DOCKET NBR: 502331 DUANE ARNOLD
RECIPIENT: STELLO, V.
ORIGINATOR: PUGH, R.
COMPANY: RICHARD PUGH, P.E.
SUBJECT:

Submits questions re fluid mechanics at subj facil as a result of 781114 pub meeting in Cedar Rapids, IA. W/encl diagrams from Cedar Rapids Gazette.

Re: Duane Arnold Energy Center
Palo, Iowa

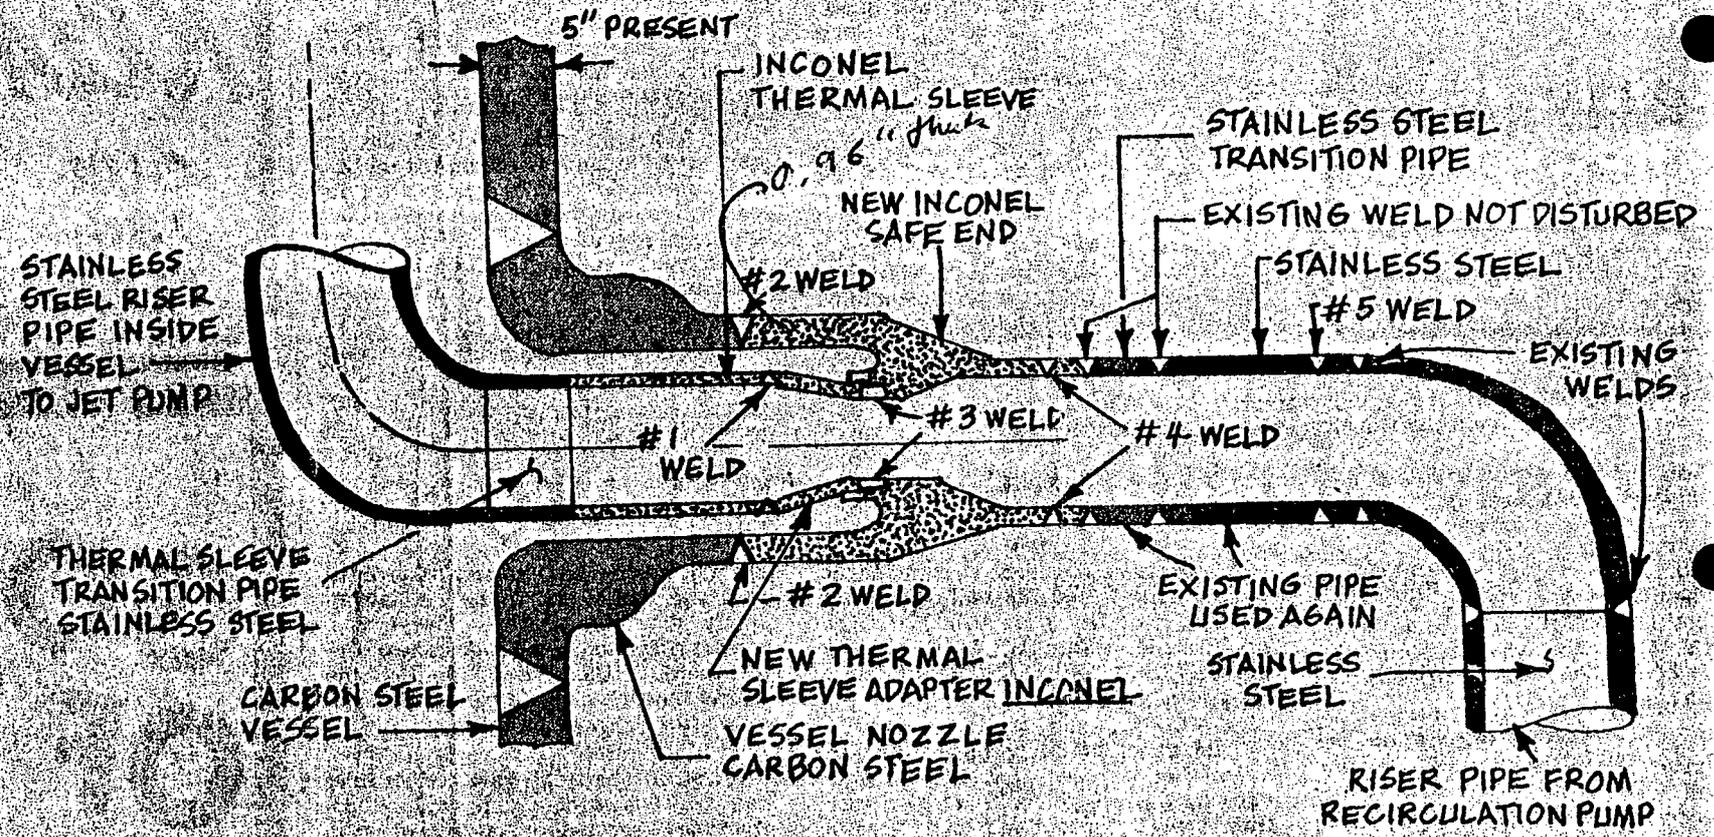
As so often happens, I think of a question too late to ask at the right time, and would appreciate your response to these questions regarding the fluid mechanics aspect. Enclosed is a copy of the new design, as it appeared in the Cedar Rapids Gazette, November 12, 1978. I assume that the constricted actually used must be smoother, and possibly less severe than that shown on the picture.

1. What is the diameter of the pipe at the # 3 weld?
2. Is the coolant water?
3. What are the temperature and pressure of the coolant in the pipe, or range of temp. and press. during normal operation?

4. What is the direction of flow of the coolant, and velocity of flow?
5. What is the anticipated pressure at the narrow cross-section (Bernoulli effect) in p.s.i. absolute?

6. What consideration has been given to possibility of cavitation of the liquid? Will the transition from full pipe diameter to constricted, and back to full diameter be ground smooth, with good radii of curvature, and will weld # 3 be ground smooth to prevent local spots where cavitation could occur? Has a prototype been tested for possible cavitation?

7. Regarding the annulus--in the scale model tests referred to yesterday to determine the flushing action, was the model operated at the same Reynolds number as one would expect for the full scale part? Was the ratio of roughness in the model to roughness in the full scale ~~xx~~ the same as the ratio of size of model to size of full scale? Was the flow in the annulus in laminar or turbulent condition?
